Author responses to Interactive Discussion Comments on “Technical Note: The impact of spatial scale in bias correction of climate model output for hydrologic impact studies” by E. P. Maurer et al.

We are grateful for the detailed and helpful comments of four reviewers of this manuscript. We respond to each of the comments below, with original review comments in regular type, and our responses in indented red italics.

Figure 1 - The change in bias in mean daily precipitation between the calibration and validation period, expressed as an absolute fraction.

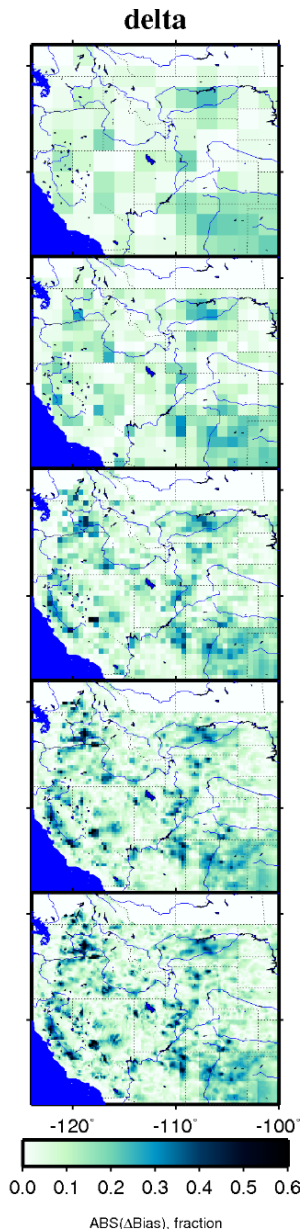
2. It looks like non-stationarity of bias is magnified in higher elevation to me (Fig3). If you agree, I think it would be great to add reason (or speculation that can be explored in the future). And do you think the illustrated impacts of the quantile mapping scale on precipitation bias are greater in complex terrain regions than flat region?

This is a helpful observation that where there is more fine-scale structure to climate that is not represented in the large-scale signal, there will generally be greater biases. We have examined this using relative changes in bias (dividing by mean precipitation), and the absolute values of the bias non-stationarity is comparable in most mountainous regions and the much less dramatic topography in the southeastern part of the domain. We can add a statement to the manuscript, in the paragraph discussing Figure 3: “Figure 3 shows the mountainous regions to have higher biases (and greater values for non-stationarity), which may be expected given greater local complexity of the terrain and thus more heterogeneity in the local precipitation that the bias correction is attempting to correct. However, the apparent higher non-stationarity in mountainous areas is also partially due to the greater precipitation at high elevations. Expressing bias as a relative change in bias (by dividing the bias at each grid cell by the mean observed precipitation) shows higher non-stationarity, and the amplification at some locations, to occur in some mountainous areas but also more broadly over much of the domain, including some prominent valleys such as California’s Central Valley. The mechanisms driving the spatial variability in bias non-stationarity, and its amplification when bias correcting at finer scales, is reserved for future research.” A figure displaying the change in bias (similarly to the last column of panels in Figure 3 in the Discussion paper) is shown below:

Figure 2 - Bias in mean annual maximum daily precipitation. This is comparable to Figure 3 in the Discussion paper, but for an extreme precipitation measure.

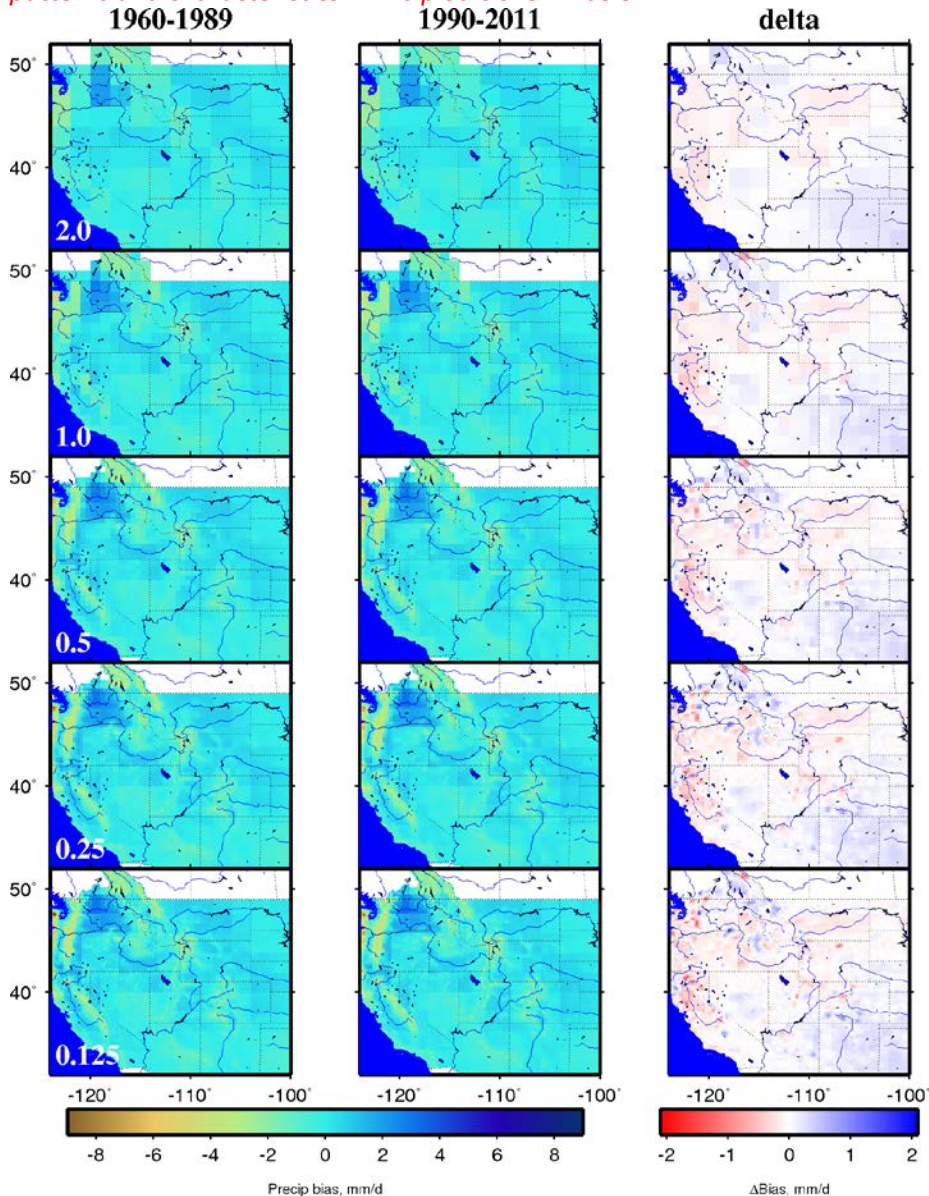
- 10901/1pp and Figure 3: This does not tell us much about the bias in the extremes. Rather show differences for extreme rainfall and length of dry spells, which better corresponds to the hydrological statistics discussed later in the text.

The revised manuscript will include a statement explaining that a similar Figure to Figure 3, but for annual maximum daily precipitation, showed a nearly identical pattern. As was noted above, the paper is already long for a Technical Note, so adding additional figures is not desirable. We will add a statement to the revised manuscript, at the end of the paragraph discussing Figure 3 to this effect: "A similar plot to Figure 3, but for annual maximum precipitation, showed similar patterns and characteristics." This plot is shown below.
